**MISSILE PROBABILITY ANALYSIS FOR THE SIEMENS 13.9M² RETROFIT
DESIGN OF LOW-PRESSURE TURBINE BY SIEMENS AG**

**SUBMITTED TO:
THE NUCLEAR REGULATORY COMMISSION AS TOPICAL REPORT TP-04124-NP-A
FOR PUBLIC RECORD**

SUBJECT: FINAL SAFETY EVALUATION REGARDING REFERENCING THE SIEMENS TECHNICAL REPORT NO. CT-27332, REVISION 2, "MISSILE PROBABILITY ANALYSIS FOR THE SIEMENS 13.9 M² RETROFIT DESIGN OF LOW-PRESSURE TURBINE BY SIEMENS AG" (TAC NO. MB7964)

RESOLUTION OF COMMENTS
ON DRAFT SAFETY EVALUATION FOR SIEMENS WESTINGHOUSE POWER
CORPORATION'S TECHNICAL REPORT NO. CT-27332, REVISION 2, "MISSILE
PROBABILITY ANALYSIS FOR THE SIEMENS 13.9 M² RETROFIT DESIGN OF LOW-
PRESSURE TURBINE BY SIEMENS AG"

Fig. 8 Tangential (at 120% of rated speed), residual and effective stress distribution in the disk #1

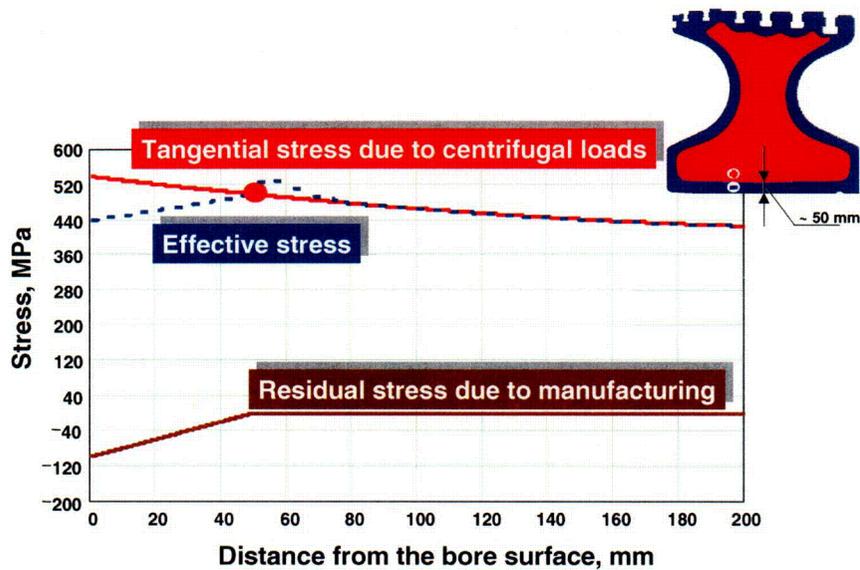
The July 22, 2003, SE discusses the Siemens turbine missile methodology without mentioning the residual stresses associated with a particular rotor disk. Since the current submittal discusses the application of the Siemens turbine missile methodology to a certain line of disk design, the disk tangential stresses, which were used in the LEFM analysis of PDBURST, include residual stresses. In regard to the NRC staff's concern over the basis for the proposed residual stress distribution (Figure 8 of the submittal), SWPC provided a Siemens technical

paper, "Shrunk on Disk Technology in Large Nuclear Power Plants - the Benchmark against Stress Corrosion Cracking," which contains the basis for the residual stress distribution along with analytical results and experimental verification. The NRC staff reviewed this paper, especially the discussion regarding the use of special heat treatment and rolling to induce compressive stresses at the disk surface. The paper indicates that the induced compressive stresses extend 50 mm into the disk surfaces as shown in Figure 8 of the submittal, and the effect of surface compressive stresses on the turbine SCC prevention is supported by test and operating data. Hence, the NRC staff agrees with SWPC's use of the residual stress distribution in this application.
